Core Design

VVDN TECHNOLOGIES	A3	Title : BATTERY_SMB358
	Fab No : 501-1-00797	Rev: A0-31
	Asy No : 701-1-00944	Sheet 20 of 22

BATTERY TESTPOINT (3000mAh Li-Po)

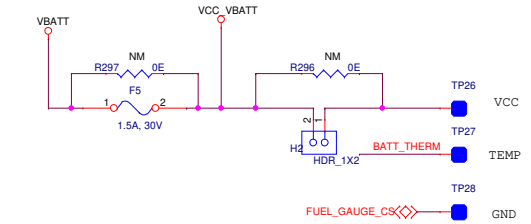
Replace Connector with Thermal Fuse
305-1-00496
